# UNITED STATES PATENT AND TRADEMARK OFFICE

APPLICATION NO.	FILING DATE	FIRST NAMED INVENTOR	ATTORNEY DOCKET NO.	CONFIRMATION NO.
10/561,637	12/19/2005	Yoshimichi Kawai	52433/831	2907

<b>Office Action Summary</b>	<b>Application No.</b> 10/561,637	<b>Applicant(s)</b> KAWAI ET AL.	
	<b>Examiner</b> William V. Gilbert	<b>Art Unit</b> 3635

**Figure 6 from Odell**

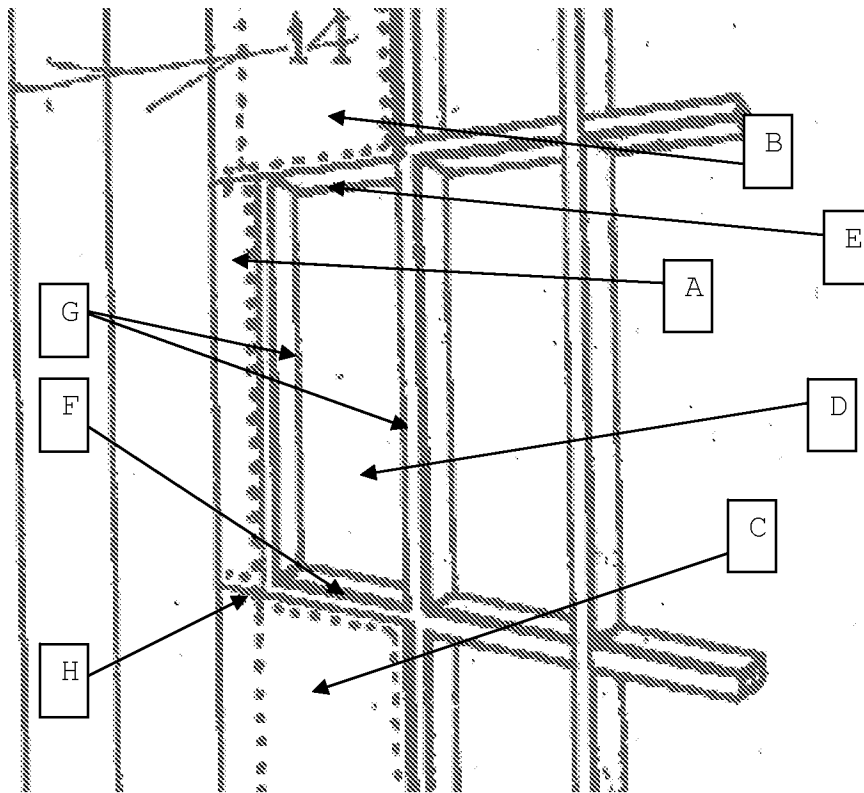
Claim 1: Odell discloses a construction of an opening (see Fig. 6: below) comprising a side face wall frame member ("A" below), a vertical panel ("B" below) and a wainscot panel ("C" below), the side face wall frame members comprise an opening ("D" below) formed by an opening upper frame member ("E") to which a lower end of the vertical panel is fixed (as shown), an opening lower frame member ("F") to which an upper end of the wainscot panel is fixed (as shown), a longitudinal frame member ("G") raised on both on both sides of the frame members, and transverse frame members (not shown, but proximate "H" below), the vertical panel (se 35 USC §112 rejection above) is integrated with upper parts of the side face wall and the

wainscot panel are integrated with lower parts of the side face wall (as shown). Odell does not disclose the limitation of having two side face wall members (i.e., a member equivalent to "A" on the other side of the opening,) which would result in the side face members being divided. It would have been obvious at the time the invention was made to a person having ordinary skill in the art as a matter of duplication of parts to have this limitation because duplication of parts has no patentable significance unless a new and unexpected result is produced. *In re Harza*, 274 F.2d 669 (CCPA 1960). See MPEP §2144.04. Odell further does not disclose the additional longitudinal members as claimed, though Bailey discloses longitudinal members (1) in pairs around a window opening. It would have been obvious at the time the invention was made to a person having ordinary skill in the art to have additional members as claimed for further strengthening the opening as needed. Odell further does not disclose that the members are made of steel, though Howell discloses a steel framing system (Col. 1, generally). It would have been obvious at the time the invention was made to a person having ordinary skill in the art to use the steel system in Howell as for the framing system in Odell because it is well known in the art to use steel framing due to its strength and durability and longer life over its wood counterpart.
